Re: Cherokee Nation WW Hastings Replacement Hospital - Addendum 02 Narrative

Following is a list of revisions included in Addendum 02.

PROJECT PHASE:
BID PACKAGE 02
(SITE DEMOLITION AND UTILITIES)

11/18/2022 A:\2021\512321\03_DSGN01_DWG\050_CIVIL\07-WATR-5123.DWG

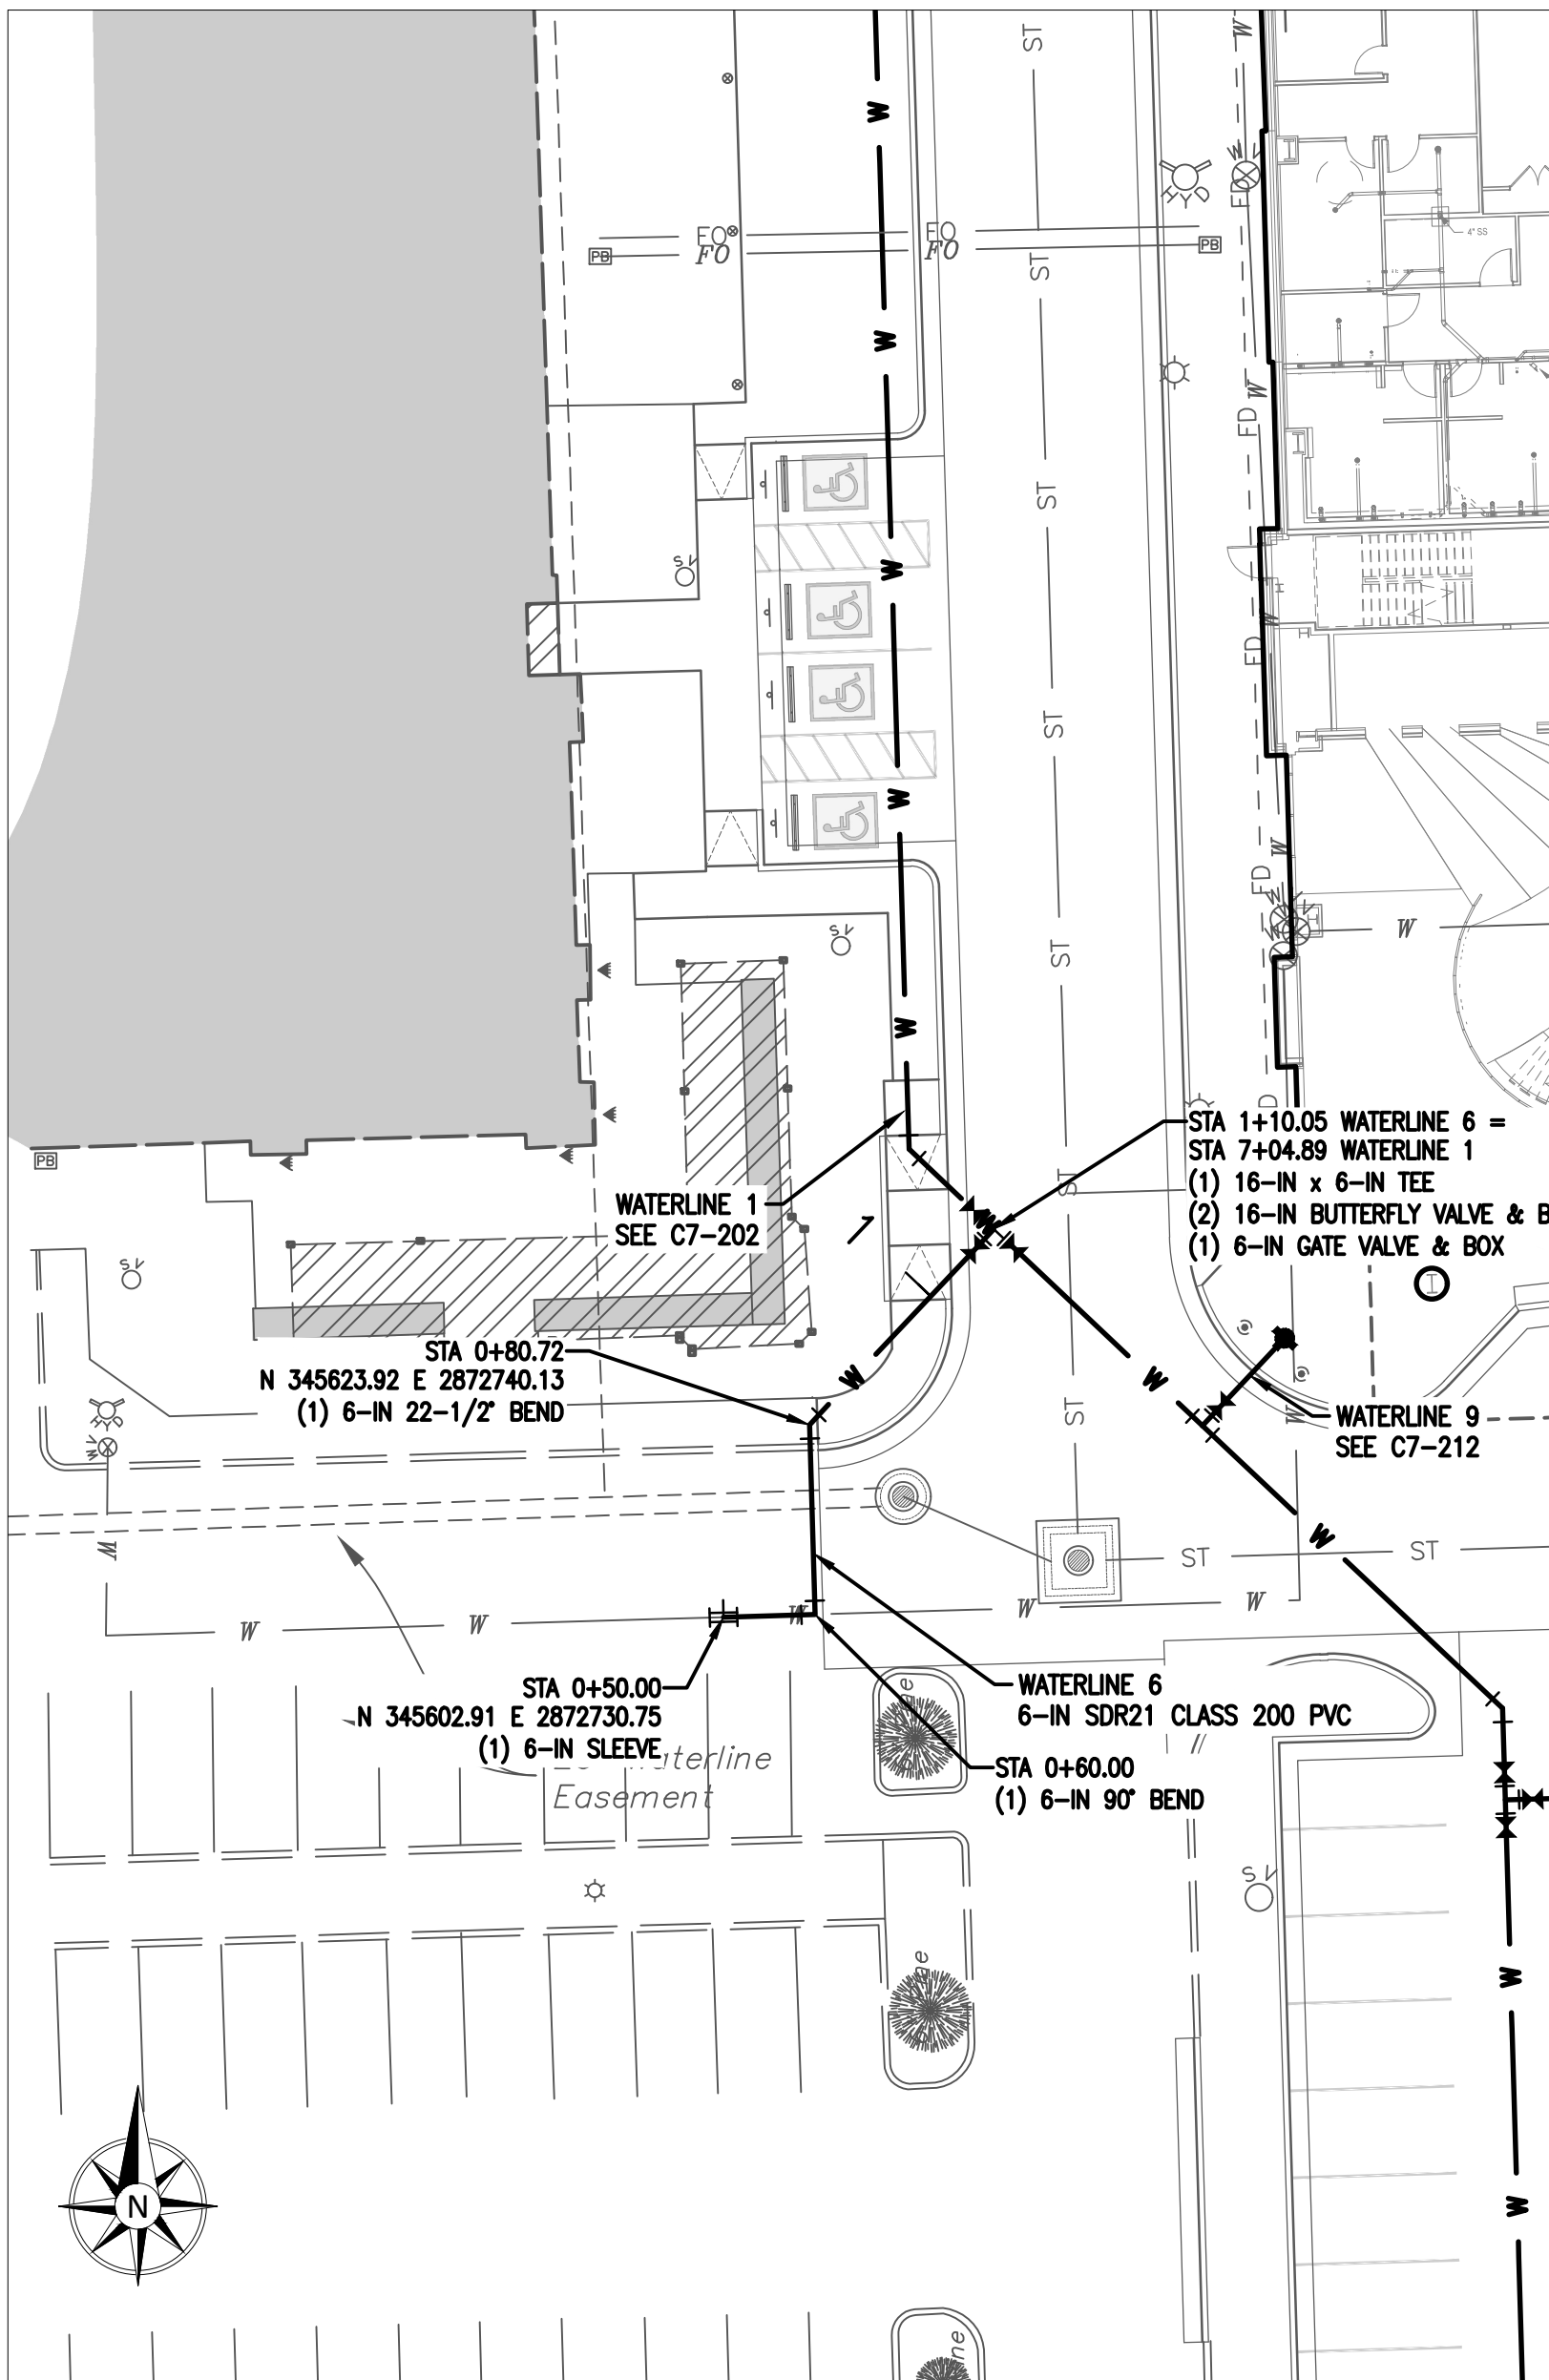
- C7-212 - Added the graphical presentation of the gate valve and fire hydrant to the profile view.
- C7-213 - Added call-outs to the materials in the plan view of Water 8.
Revised the profile view of Water 8 to match the plan.
Added labels to the plan view of Water 13.
